Item ID: D2580-1 Accept ***N900040100*** Setup Start ***NS1***
Revision ID: Stop ***NS2***
Item Name: 205 Skidtube bent detail
Start Date: 03/01/2012 Start Qty: 2.00 *?
Required Date: 05/01/2012 Req'd Qty: 2.00 *?
Reference: Cust Item ID:
Customer:

Item Name: 205 Skidtube bent detail

DRAWING NO. D2580	TITLE 205 SKIDTUBE ASSEMBLY	REV. E	DART AEROSPACE LTD ENGINEERING ORDER		D.E.O. NO. D2580-E-1	SHEET NO. SHEET 1 OF 1	SCALE NTS
DRAWN <i>UP</i>	CHECKED <i>ASS</i>	MFG. APPR. <i>EC</i>	APPROVED <i>[Signature]</i>		DE APPR. <i>[Signature]</i>		
DATE 11.12.13	DATE 11.12.13	DATE 11.12.13	DATE 11.12.13		DATE 11.12.13

SECTION B-B, F-F, I-I
NOT TO SCALE

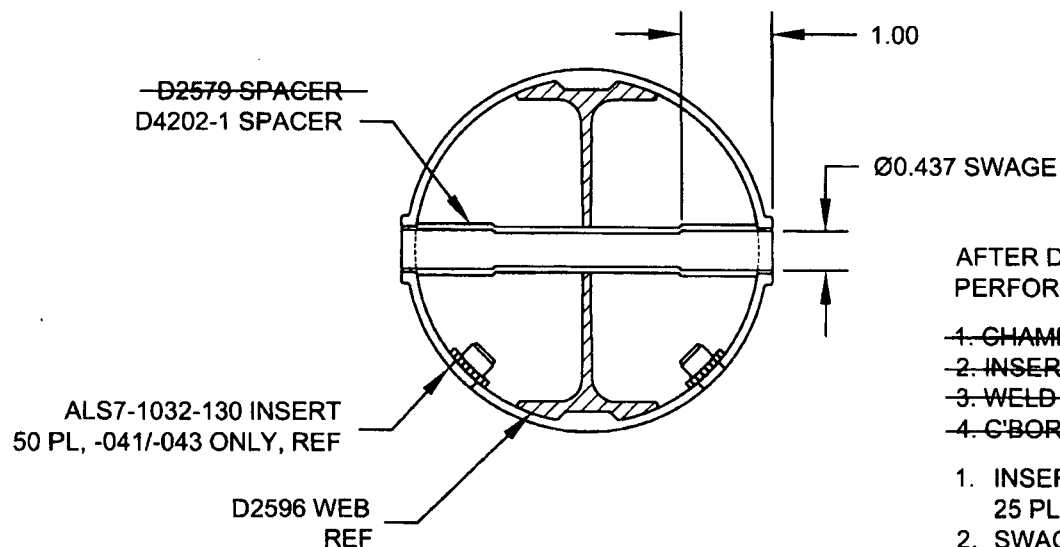
CHANGE ALL C'BORED WELDED CROSSBOLT SPACERS TO SWAGED SPACERS

SECTION B-B, SECTION F-F, & SECTION I-I ARE AMENDED AS FOLLOWS
FOR ALL HOLES THAT WERE ORIGINALLY C'BORED:

1. CHAMFER HOLE 0.050 X 45°
2. INSERT D2579 SPACER (20 PLACES)
3. WELD INTO PLACE AND GRIND FLUSH
4. C'BORE D2579 SPACER TO Ø0.437 X 1.00 DEEP

*** FOR -045 SKIDTUBE ONLY:**
WELD 4X D2579 SPACERS PER DWG
IN LOCATIONS MARKED "NO C'BORE".
REF SHEET 4 OF DWG.

1. INSERT D4202-1 SPACER, 20 PL (-041) OR 20 PL (-045) OR 25 PL (-047)
2. SWAGE TO Ø0.437 X 1.00 DEEP PER QSI 002
3. TRIM / GRIND FLUSH PER QSI 002
